Access Compliance Report Public Rights-of-Way (Pedestrian Signals)

Main Street: **EDINGER_AVE** Cross Street: **HARBOR_BLVD** Location: **SE**

ADA ID: **SGRK220222161504** Signal Type: **One Push Button-Non APS** Overall Compliance: **No** Severity Scores: **BTN 1: 10 BTN 2: N/A No BTN: N/A**

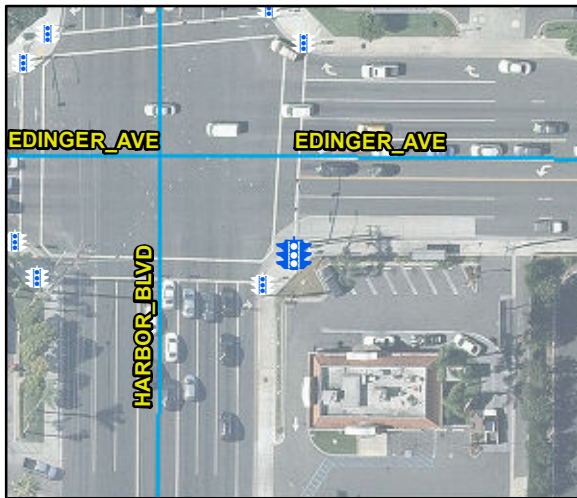
N/A Is Button 1 APS or Non-APS?	NonAPS	N/A Is Button 2 APS or Non-APS?	N/A
N/A B 1 VibroTact Arrow?	N/A	N/A B 2 VibroTact Arrow?	N/A
N/A B 1 VibroTact Parallel to Xing?	N/A	N/A B 2 VibroTact Parallel to Xing?	N/A
N/A B 1 VibroTact Contrast	N/A	N/A B 2 VibroTact Contrast	N/A
No B 1 Pilot Light?	No	N/A B 2 Pilot Light?	N/A
N/A B 1 Pilot Light Illumination?	N/A	N/A B 2 Pilot Light Illumination?	N/A
N/A B 1 Walk Indicator Type	N/A	N/A B 2 Walk Indicator Type	N/A
N/A B 1 Walk Indicator Audible?	N/A	N/A B 2 Walk Indicator Audible?	N/A
N/A B 1 Locator Tone?	N/A	N/A B 2 Locator Tone?	N/A
N/A B 1 Tone Audible Range?	N/A	N/A B 2 Tone Audible Range?	N/A
B 1 Addl APS Features?	No	B 2 Addl APS Features?	N/A
B 1 Addl APS Features Notes	N/A	B 2 Addl APS Features Notes	N/A

Possible Solutions: Replace Signal Push Button With APS Button.
